Access Compliance Report

Public Rights-of-Way

(Curb Ramps)

Intersection ID: 17663	Main Street: TRANQUIL_AV	Cross Street: WESTFIELD_RD	Location:	N
ADA ID: C9CCD52C813B	Ramp Type: PerpDiag	Initial Pass/Fail: Fail	Overall Compliance: No	Severity Score: 35
Codes/Mitigation Info/Possible Solution		Field Measurements/Component Compliance

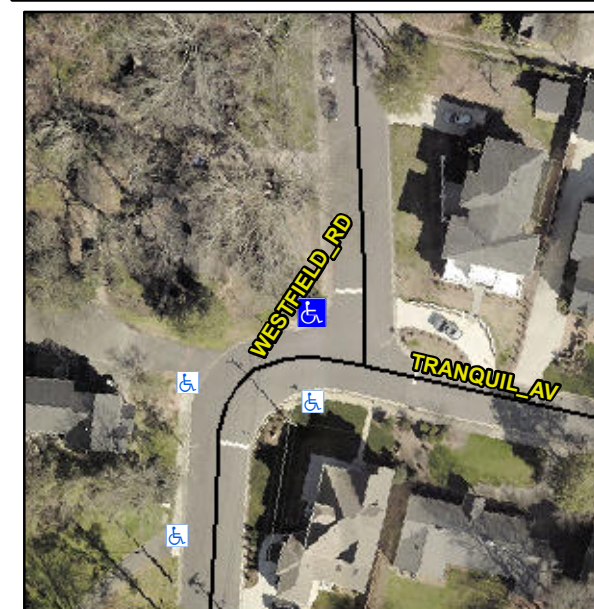
Not Found, R304.5.1, R304.2.2, R304.5.3

Compliance	Description	Data	Compliance	Description	Data
N/A	Ramp Length (in)	48.0	No	Ramp Slope (%)	12.6
No	Ramp Width (in)	38.0	No	Ramp XSlope (%)	3.6
N/A	Flare Type LT	N/A	N/A	Flare Type RT	N/A
N/A	Flare Slope LT (%)	N/A	N/A	Flare Slope RT (%)	N/A
N/A	Flare Traversable LT?	N/A	N/A	Flare Traversable RT?	N/A
N/A	Landing Length (in)	N/A	N/A	DWS Provided?	N/A
N/A	Landing Width (in)	N/A	N/A	DWS Contrast?	N/A
N/A	Landing Slope (%)	N/A	N/A	DWS Length (in)	N/A
N/A	Landing X Slope (%)	N/A	N/A	DWS Full Width?	N/A
N/A	Landing Curb? (Y/N)	N/A	N/A	DWS Offset (in)	N/A
N/A	Shared Landing?	N/A			
N/A	Gutter Ponding?	N/A	N/A	Gutter Slope (%)	N/A
N/A	Gutter Lip Ht (in)	N/A	N/A	Gutter X Slope (%)	N/A
N/A	Painted X Walk1?	No	N/A	Painted X Walk2?	No
	X Walk 1 Direction	To S		X Walk 2 Direction	To E
N/A	X Walk 1 Width (in)	N/A	N/A	X Walk 2 Width (in)	N/A
	X Walk 1 Slope (%)	6.7		X Walk 2 Slope (%)	9.5
	X Walk 1 X Slope (%)	5.6		X Walk 2 X Slope (%)	4.2

Remove & Replace Curb Ramp With Two New Directional Ramps or Equivalent.
